APPLICATION ON NOTIFICATION (Re-Notified) –211/M015/19

Applicant:	Plympton Apartments Pty Ltd C/Future Urban
Development Number:	211/M015/19
Nature of Development:	Demolition of existing structures and construction of a seven level residential flat building comprising 35 dwellings and associated car parking
Development Type:	Merit
Subject Land:	1 & 1A Glenburnie Terrace, Plympton
Development Plan:	West Torrens Council, consolidated 12 July 2018
Zone / Policy Area:	Urban Corridor Zone/ Boulevard Policy Area 34
Contact Officer:	Janaki Benson
Phone Number:	08 8343 2339
Consultation Start Date:	26 March 2020
Consultation Close Date:	5pm 08 April 2020
<p>During the notification period, hard copies of the application documentation can be viewed at the Department of Planning, Transport and Infrastructure, Level 5, 50 Flinders St, Adelaide, during normal business hours. Application documentation may also be viewed during normal business hours at the local Council office (if identified on the public notice).</p>

**RESPONSE TO REQUEST FOR FURTHER INFORMATION AND REFERRAL
COMMENTS RECEIVED IN RELATION TO DA 211/M015/19 AT
1 AND 1A GLENBURNIE TERRACE, PLYMPTON.**

FIGURE 3.3 MINIMUM SIGHT LINES FOR PEDESTRIAN SAFETY

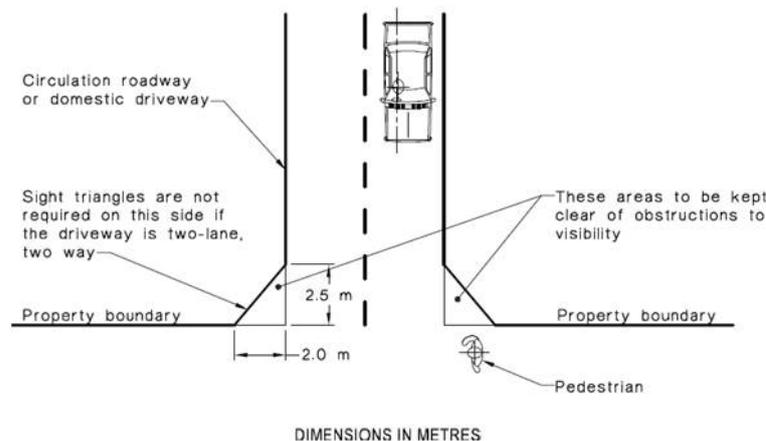
Mr Phil Weaver of Phil Weaver and Associates has reviewed these sightlines, and has provided the following comments:

Pedestrian vehicle sight line requirements are addressed within the above car parking standard as per Figure 3.3 Minimum Sight Lines For Pedestrian Safety which I have reproduced below:

While the above figure suggests that the sight line would need to be measured from the property boundary, in reality, the requirements should be assessed from the edge of the footpath which currently is offset from the boundary of the subject site. Furthermore, the design of the proposed development indicates that the footpath would be relocated even further to the north. On this basis the 2.0 metre wide by 2.5 meter deep sight distance splay could be fully provided as per the figure below.

Given that relocation of the footpath would be subject to the agreement of Council it may not be possible to fully meet the sight distance splay requirements based on the current design / footpath location. However, there would appear to be some opportunity, if necessary, to slightly relocate the transformer to the south which would ensure that even in the event that the location of the footpath remains unchanged, appropriate pedestrian vehicle sightlines could still be provided.

Further to Mr Weaver providing this advice, it has been confirmed that the proposal does not require a transformer. As such, should the SCAP consider it necessary, the layout of this building corner can be amended to provide the necessary sightlines to the property boundary, as opposed to the footpath.

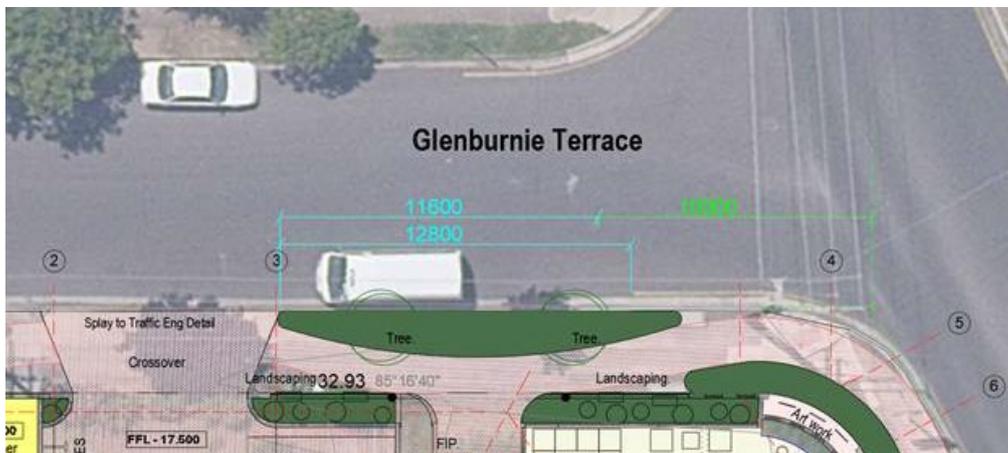
2.13 It should be assumed that no car parking will be available in front of the subject site due to the requirement for a 10m separation between the crossover and the intersection and the required waste vehicle turn path.

Again, Mr Phil Weaver reviewed this separation distance, and has provided the following comments:

There would actually be an opportunity to park up to 2 cars in front of the site between the 10 metre prohibited distance from the adjoining side road (Gray Street) and the eastern edge of the proposed crossover given that this length would be approximately 12.8 metres (refer below) or 11.6 metres if the existing 'No Stopping' restriction (yellow line) was extended to the full 10m prohibited distance.

In either case, such a distance would accommodate two on-street car parking spaces given that a minimum 10.8 metres would be provided for these open-ended spaces.
